ON-SITE SEWAGE DISPOSAL SYSTEM HOWARD COUNTY HEALTH DEPARTMENT BUREAU OF ENVIRONMENTAL HEALTH

ADDRESS: 1894 Daisy Road PROPERTY OWNER: Raymond Gipard

SEWAGE DISPOSAL SYSTEM

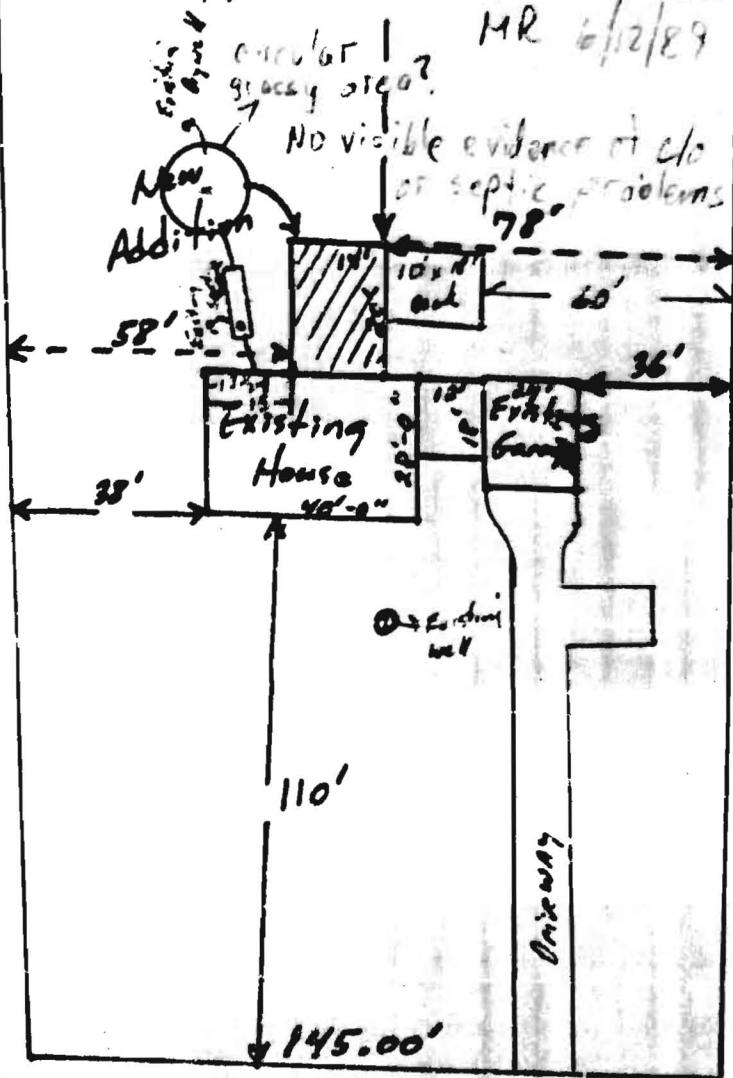
Tank is 13 1/2' in from house corner, proposed addition 15' from house corner

Potential exists for damage to tank. Approval NOT Recommended
